**Final submission from
William Turner**

Application from the CNL to amend its Chalk River Laboratories site licence to authorize the construction of a near surface disposal facility

**Commission Public Hearing
Part 2**

Final Submission by W. Turner
Addressing CNL's Answers & Engineered Containment.

Slide 32 - Issue 2 – Non-Rad Contaminants Criterion 5 – Uncertainties. Please provide a description of CNL’s systematic approach to addressing uncertainties in both models and measurement.

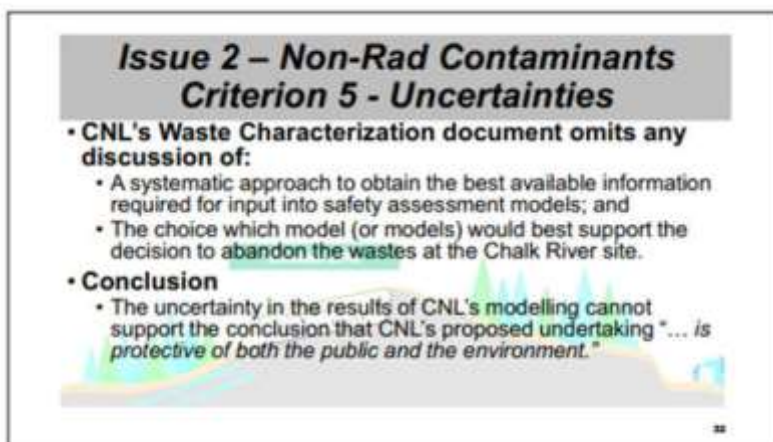
Whether or not CNL’s Safety Case [6] addresses uncertainties, this question addresses CNL’s *Waste Characterization* report [13]. As stated on this slide, this document “...omits any discussion of...” a systematic approach to addressing uncertainties in measurement.

2.4.1 CNL’s Answer

Section 6 of the NSDF Safety Case provides detailed information on the management of uncertainties.

Figure 1: Depiction of the Mound Extracted from Slide 24 (CNL's CMD 22H7.1A)

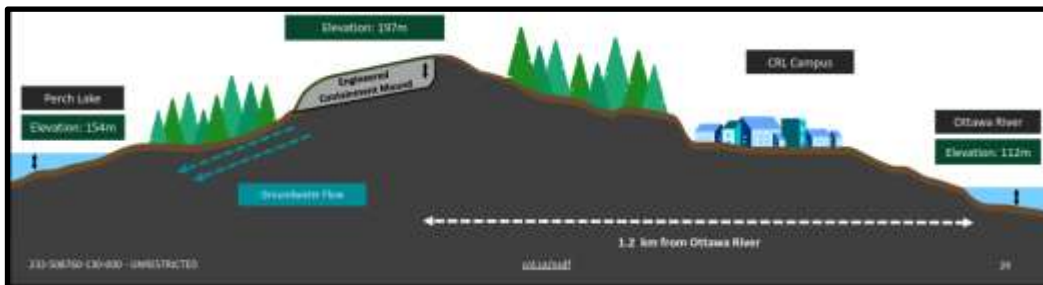
As can be seen in Figure 1, the Mound has no natural containment and isolation features. Moreover, as described above, the characteristics of the base-liner are "synthetic" not natural.

Figure 2: Statement of Qualifications and Limitations from CNL report [13]

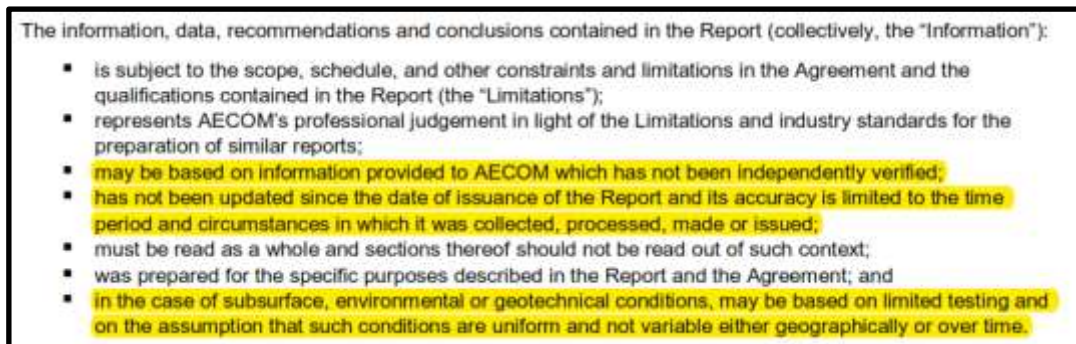
CNL's answer above does not provide "A clear description of the characterization process used to verify the Inventory". Furthermore, neither does CNL's Waste Characterization report, [13] (see Figure 2),

Figure 4: Extract from Dr. Rowe’s “Statement and Limitations” [4]

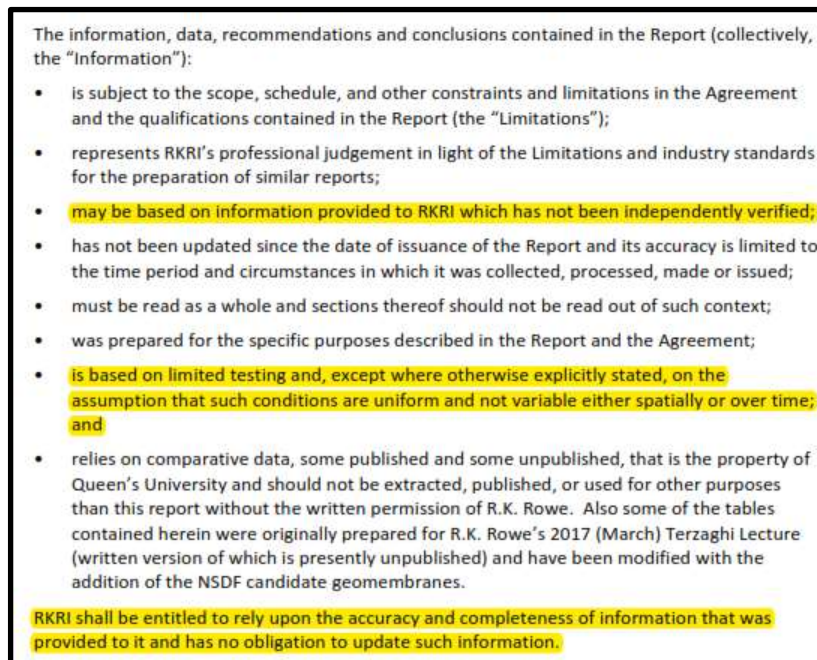
Figure 4 (below) was extracted from the two page “*Statement of Qualifications and Limitations*” contained in his report [4]. Several statements are highlighted in yellow.

Consider the highlighted statements. To quote:

*“The information ...may be **based on information** provided to RKRI **which has not been independently verified**...”;* and

*“...is **based on limited testing** and ...on the assumption that such conditions are uniform and not variable either spatially or over time...”;* and

*“**RKRI shall be entitled to rely upon the accuracy and completeness of information that was provided to it and has no obligation to update such information.**” [emphasis added]*

Are any of these assertions “over-predictions” (see Section 2.3.2.1 above)?

How do these assertions relate to any new evidence required to support the decision?

Since “*RKRI ...has no obligation to update such information*”, then without an update, the current evidence is unlikely to be the “best available”. Without up-to-date knowledge, “...*the most appropriate course of action*...” cannot be determined (see Figure 3).
